# Product Change Notification

**Product Change Notification:** E-19-019826

DUAL ROW SURFACE MOUNT HEADERS, RIGHT ANGLE, SURFACE MOUNT, METAL AND PLASTIC HOLDDOWN, ASSEMBLY, TIN, 15 AND 30 GOLD

**MARKED COPY  
 DEC, 19TH, 2019  
 BY Washington**

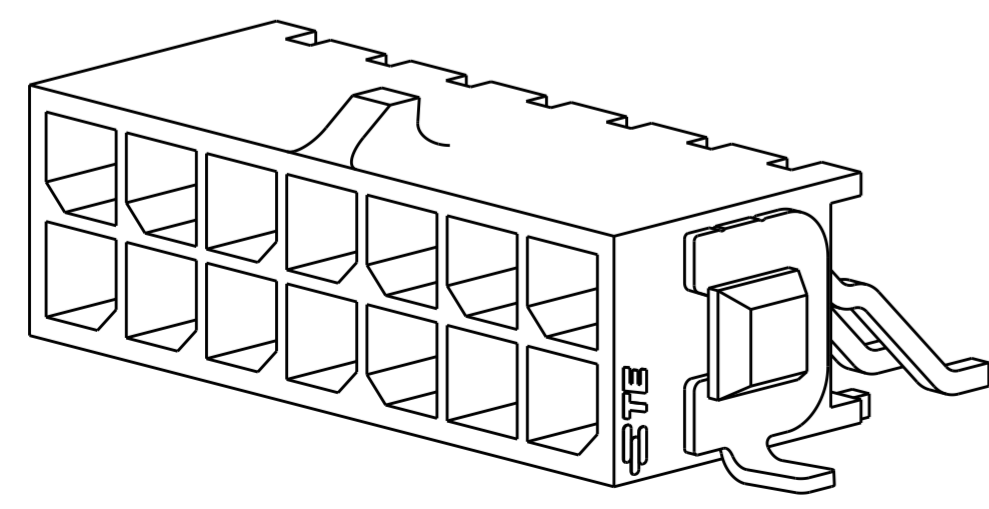
OTHER DIMENSIONS AND REFERENCES WERE SPECIFIED TO DEFINE POSITION OF THE TERMINALS IN THE ASSEMBLING.

Product Improvement. IMPROVEMENT OF PRODUCT SPECIFICATION. THERE IS NO PHYSICAL MODIFICATION, BUT JUST A SPECIFICATION MODIFICATION. MARKED COPY DRAWING OF THE PN 794627 IS THE MODEL FOR THE OTHER PNS MODIFIED.
